GEOTECHNICAL SERVICES
RIO SALADO IMPROVEMENT

Near Farmer Avenue to McClintock Drive
Tempe, Arizona

Re Bed Material Gradation

Re Indian Bend Wash Drop Structure

Figure 1

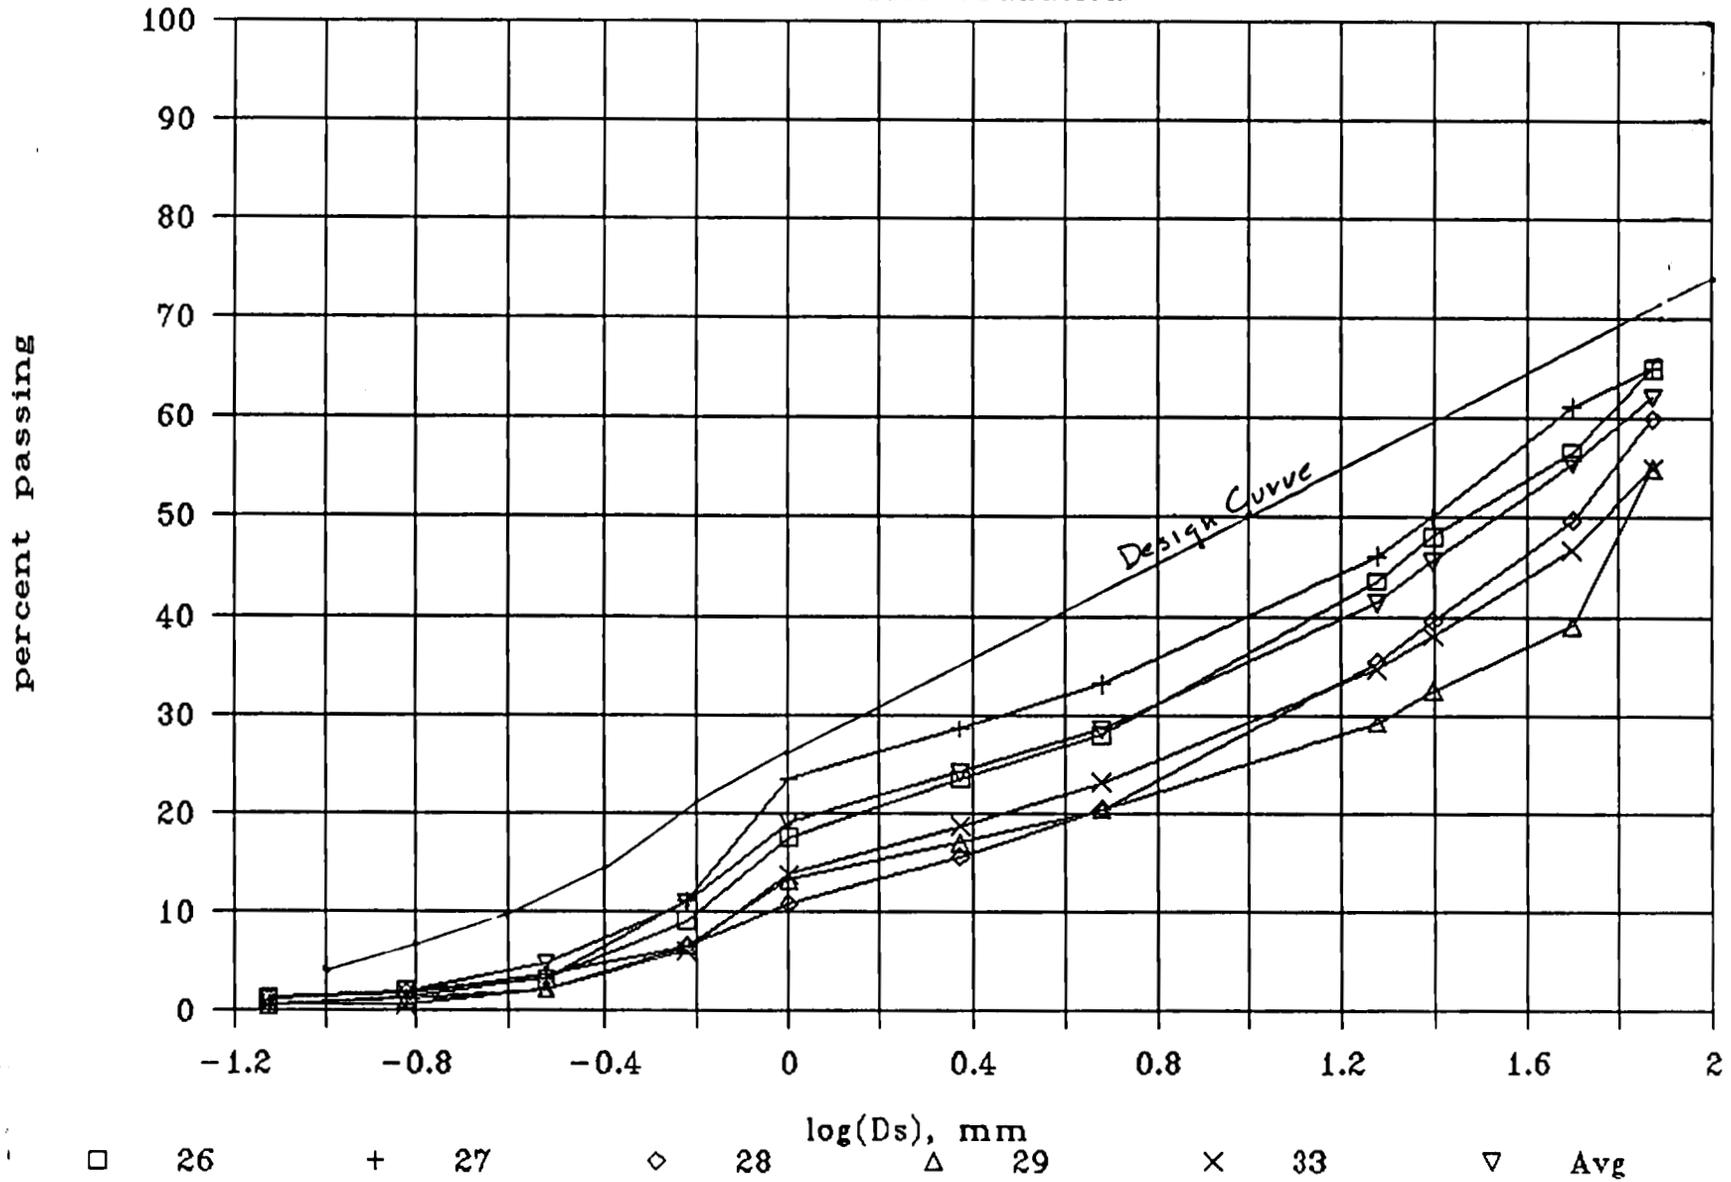
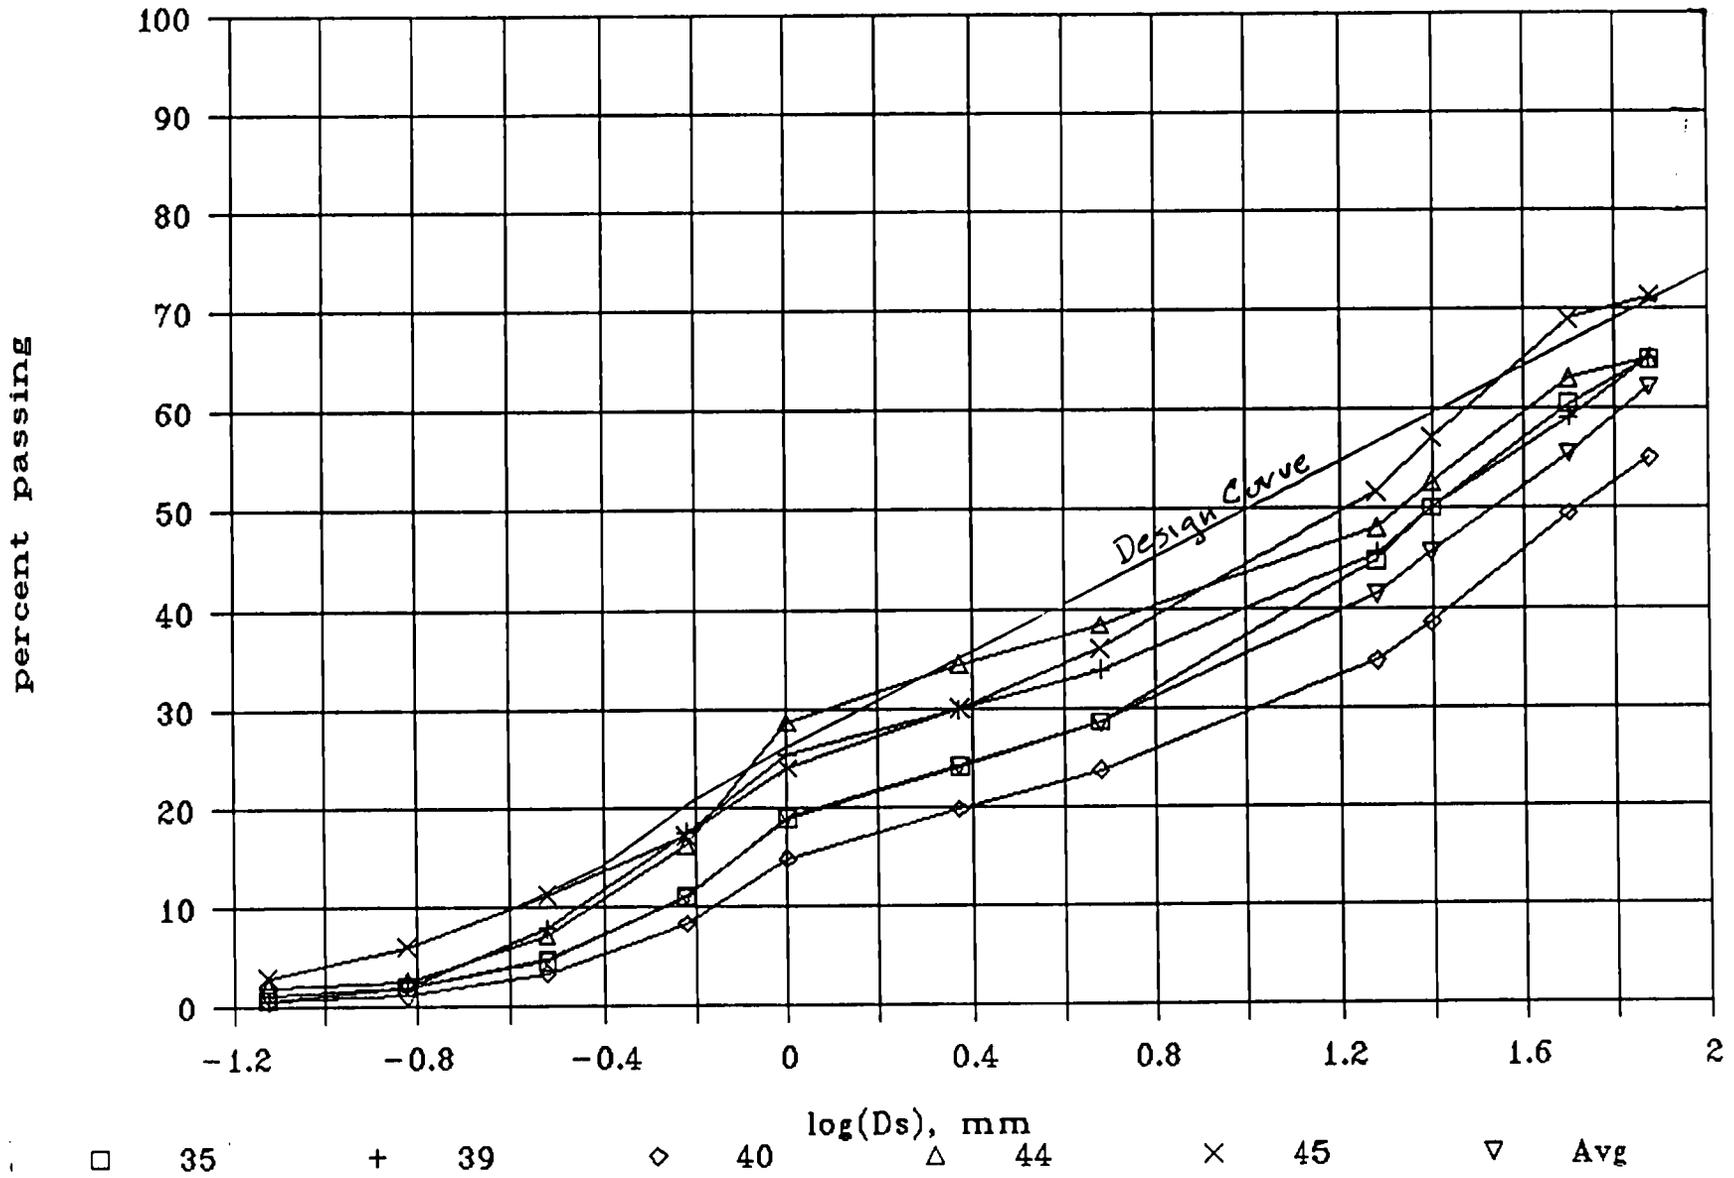
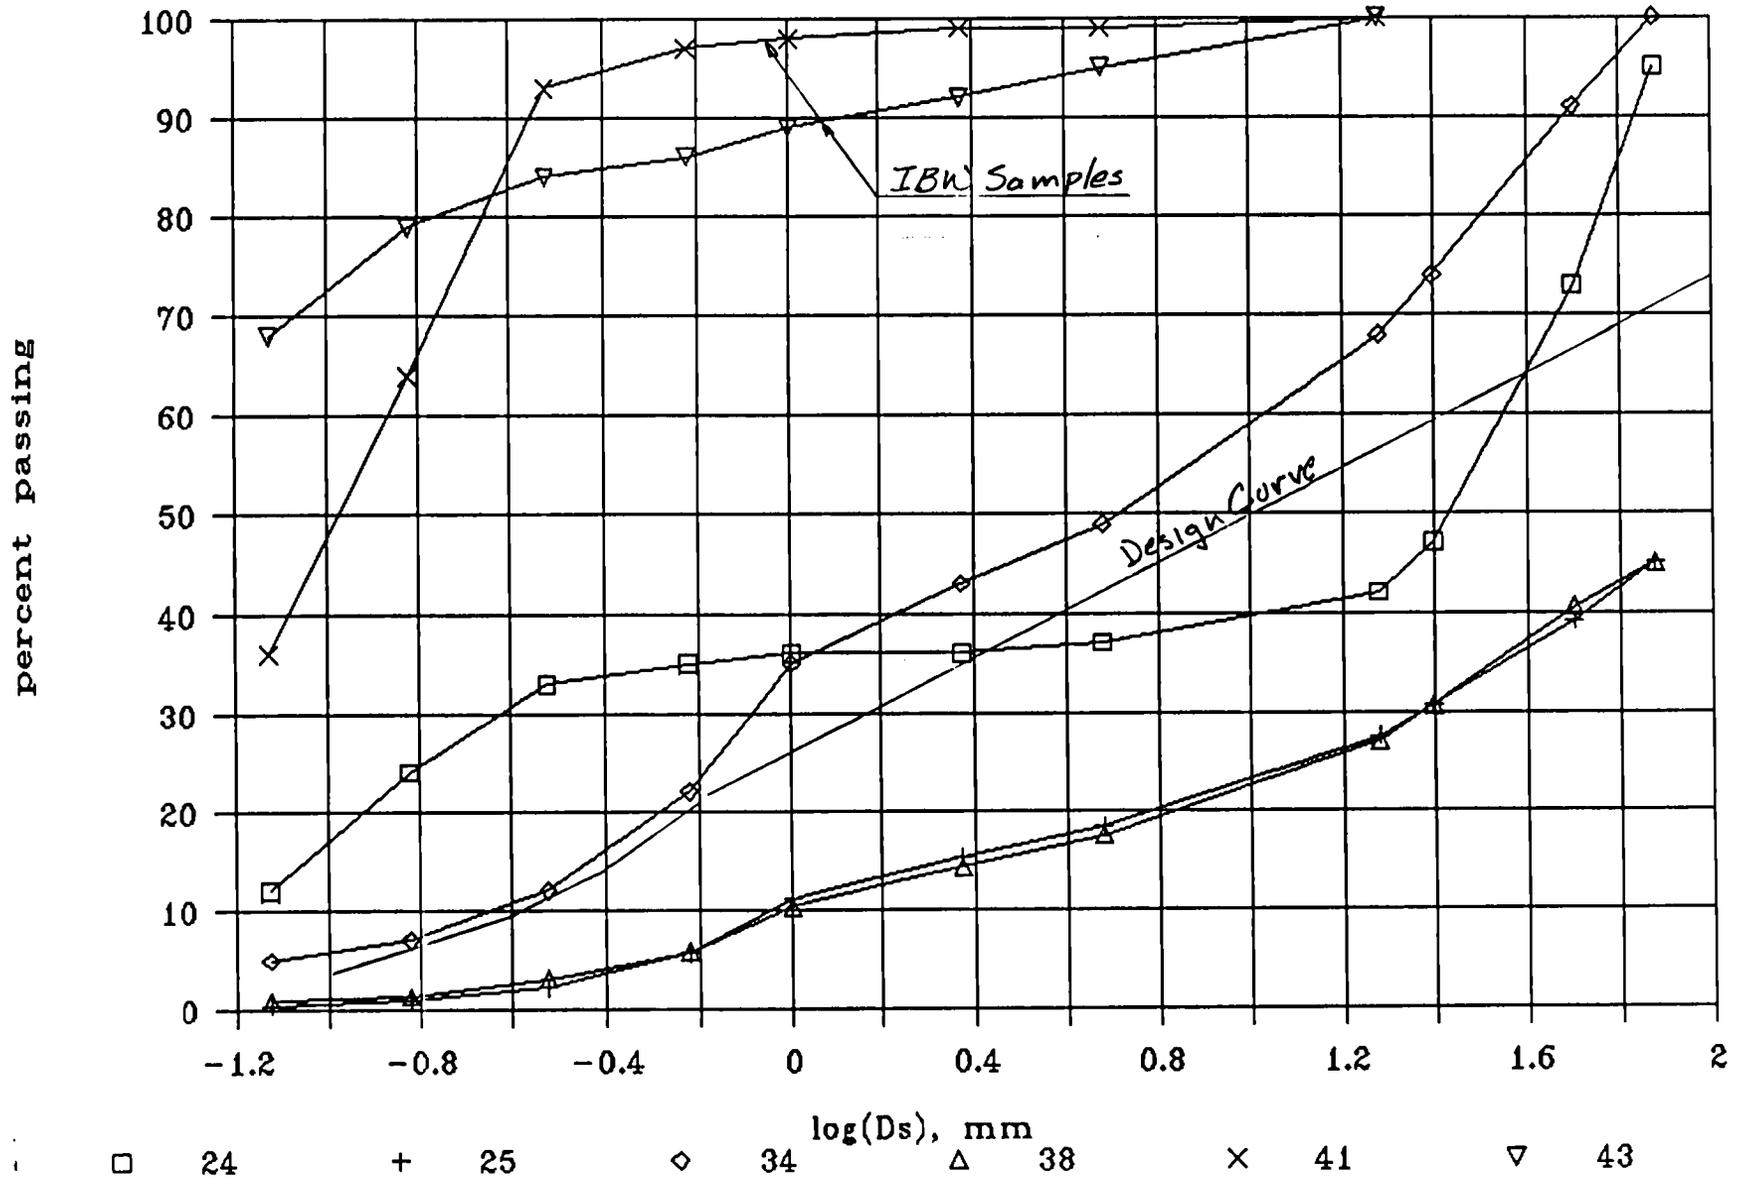
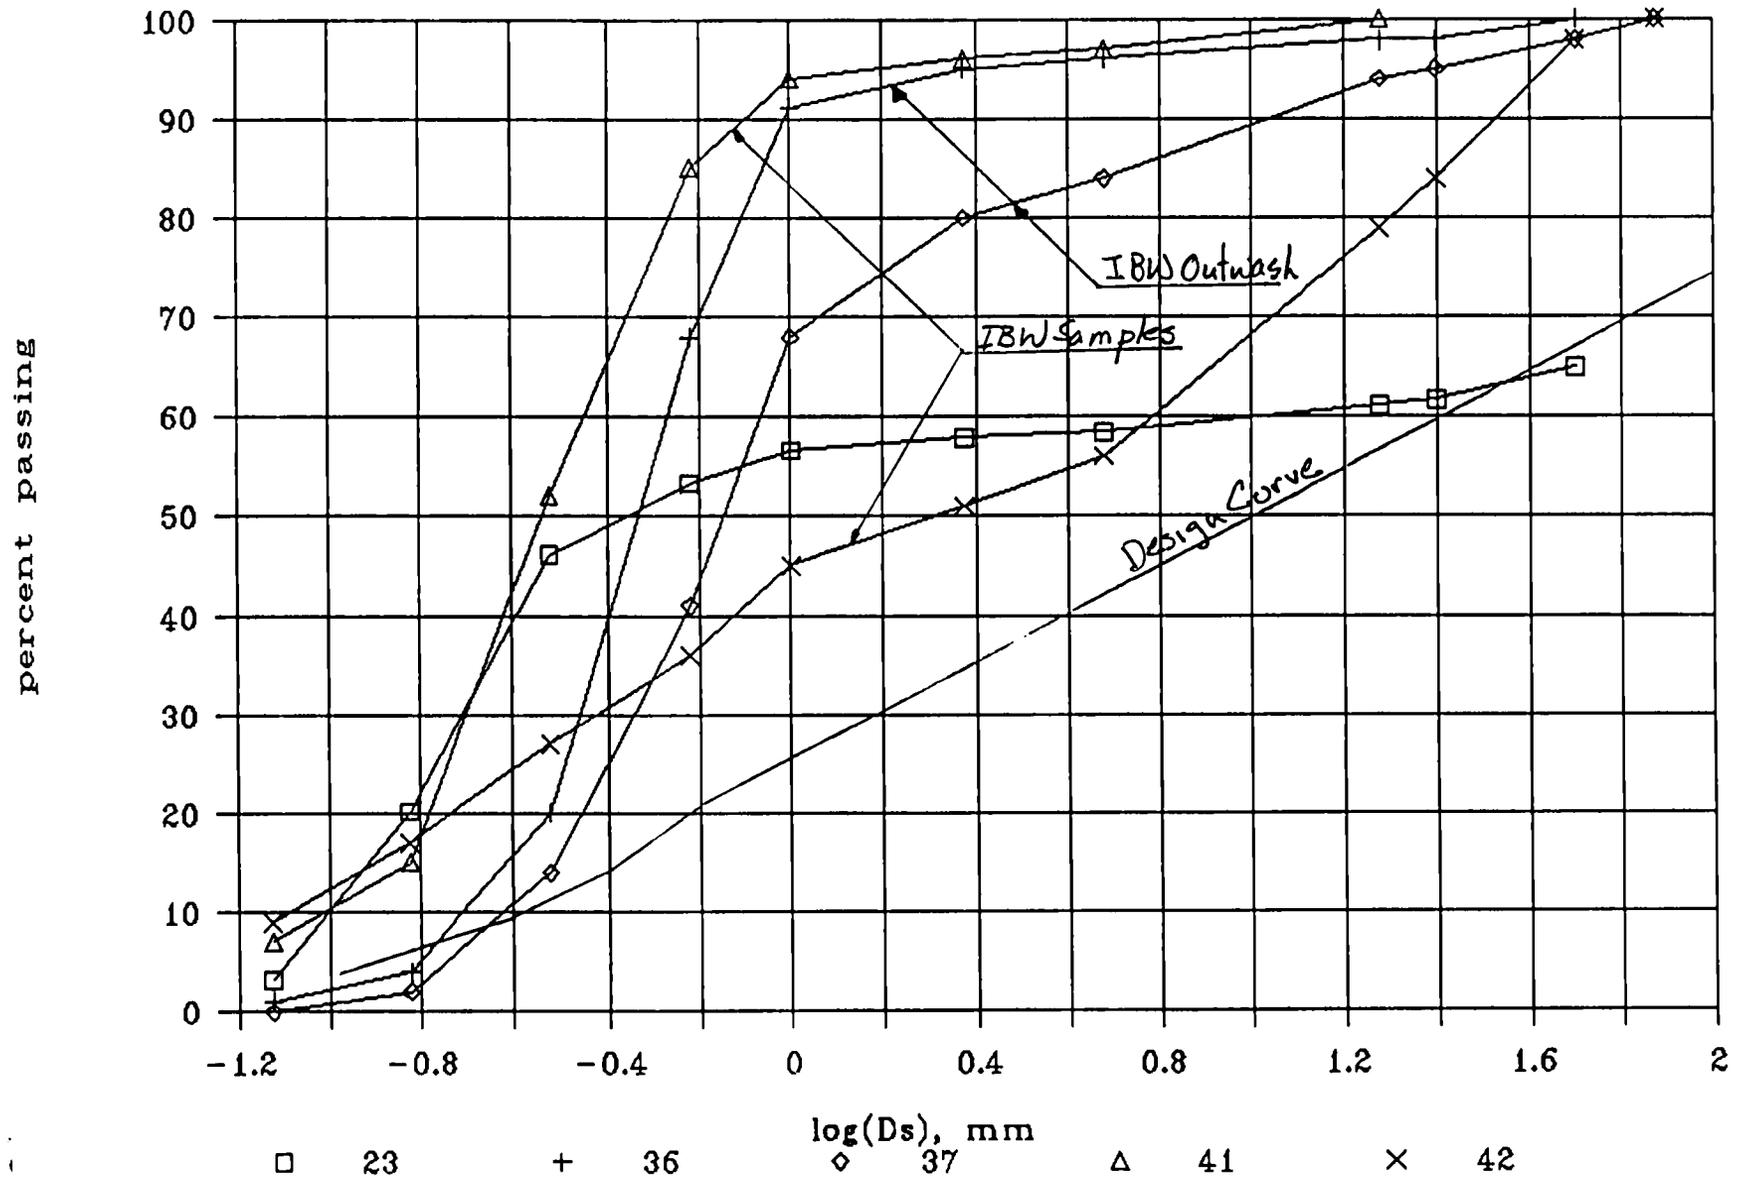
The measured gradations were plotted for the purpose of identifying a design gradation (see Figures 1 to 4). Two groupings of gradation measurements were identified. The first group consisted of 12 samples taken at various locations in the Salt River channel (samples 25, 26, 27, 28, 29, 33, 35, 38, 39, 40, 44 and 45). The second group consisted of six samples taken at locations in the Indian Bend Wash channel (samples 41 [surface and subsurface], 42 and 43) and at two locations immediately downstream of the Indian Bend outlet in the confluence with the Salt River channel (samples 36 and 37).

Based on this sampling, the mean diameter of the Salt River bed material ranges from 10mm to 60mm, while the mean diameter for the Indian Bend Wash gradations is substantially finer and ranges from 0.1mm and 1.0mm. Three remaining samples (samples 23, 24, and 34) occur in the Salt River channel and include finer sediment sizes relative to the more typical Salt River gradation. Samples 23 and 24 are gap graded with sizes less than 1.0mm and greater than 50mm occurring. Sample 34 is generally finer relative to the typical Salt River gradation, with a mean diameter of about 3.0mm compared to 10.0mm, respectively.

The design gradation was based on an envelope curve which was plotted at the upper limit of the group of 12 samples for the Salt River. The three gap-graded samples were

excluded from the analysis, since they do not represent any consistent gradation trend in the river but rather a local variation in the gradation due to the sedimentation process.

Figure 5

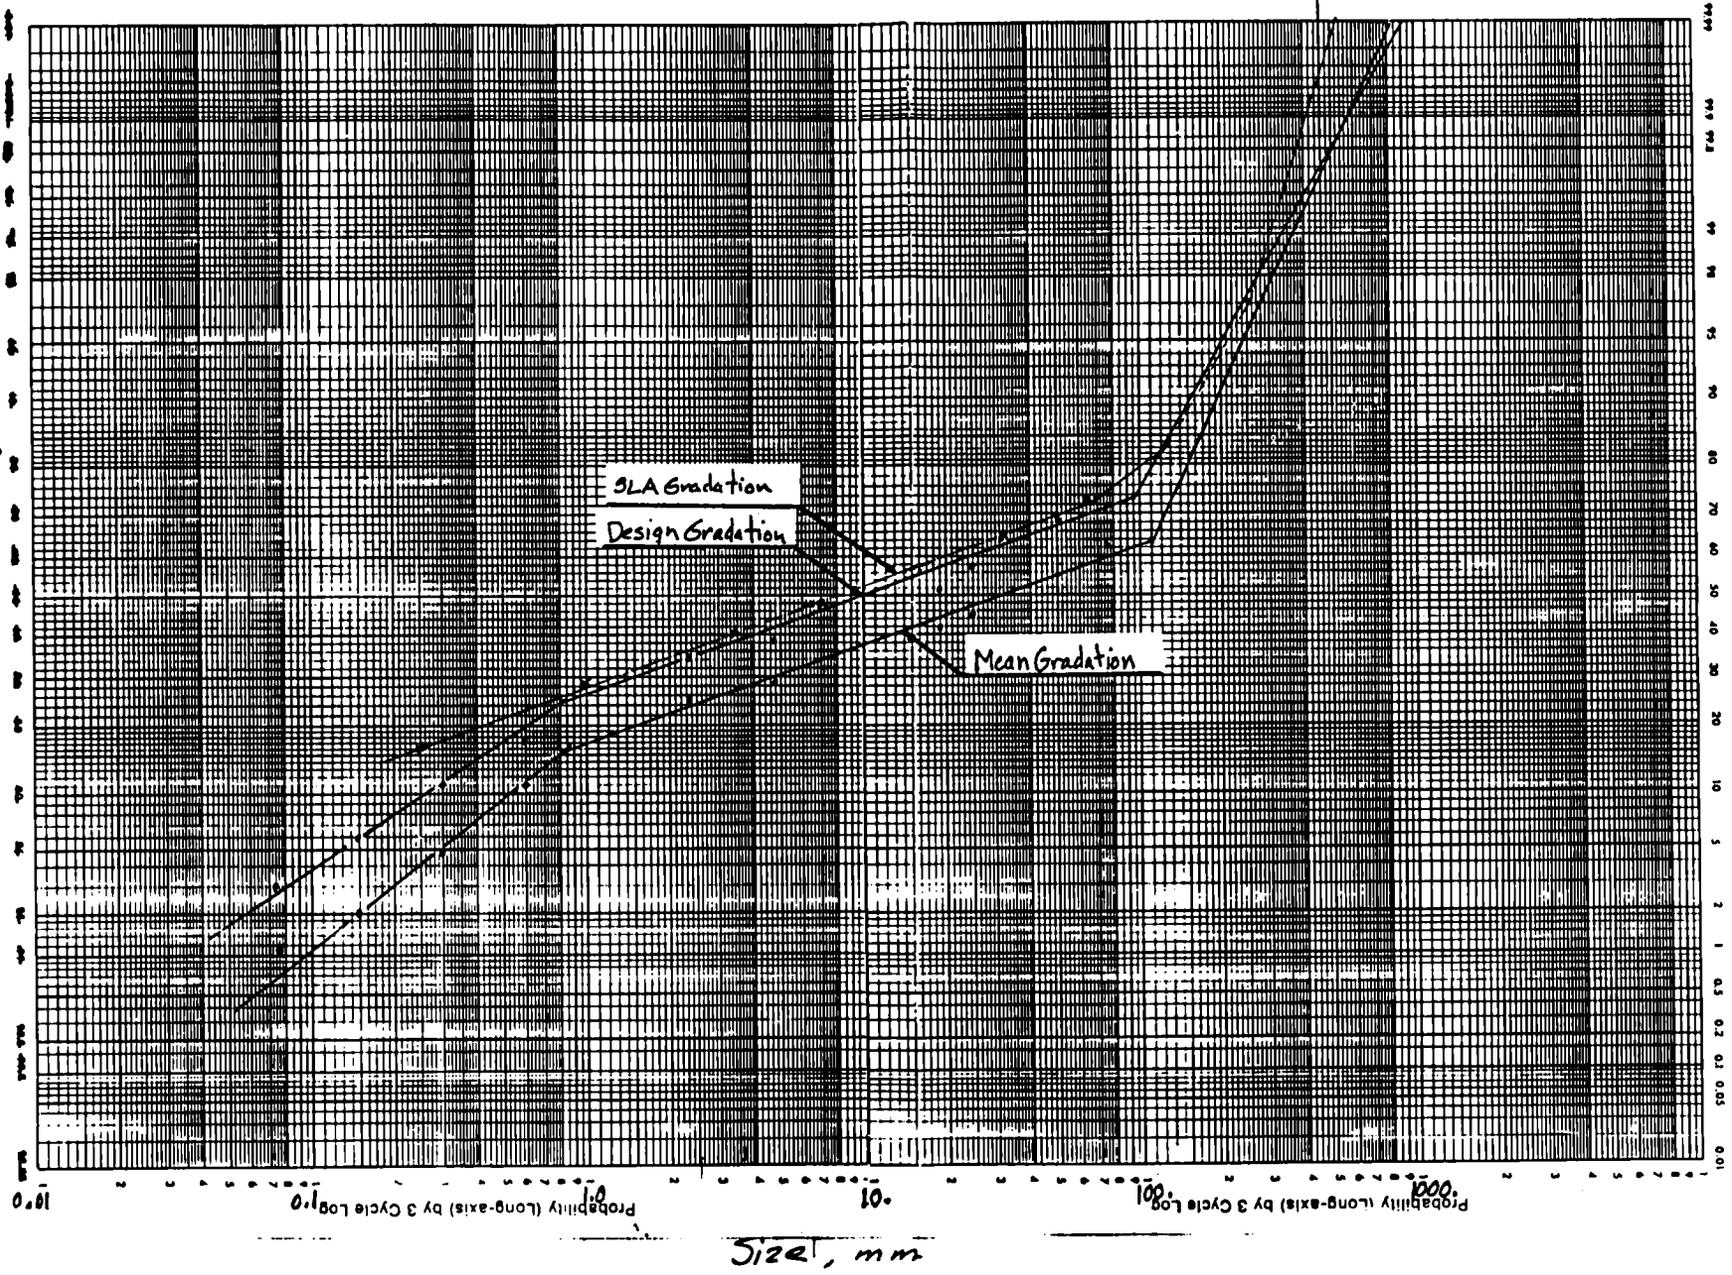
The design gradation was compared to the Simons, Li & Associates design gradation which was developed for the ADOT channel design (see Figure 5). The two design gradations are essentially the same, which indicated that there is a fairly representative bed material gradation in the Salt River channel through Tempe. The confluence with Indian Bend Wash locally changes the gradation of the Salt River; however, most of this change is surficial and has not mixed with the characteristic Salt River gradation. Therefore, from the standpoint of channel response in the Salt River, the characteristic Salt River gradation will be most important for use in evaluating the potential scour.
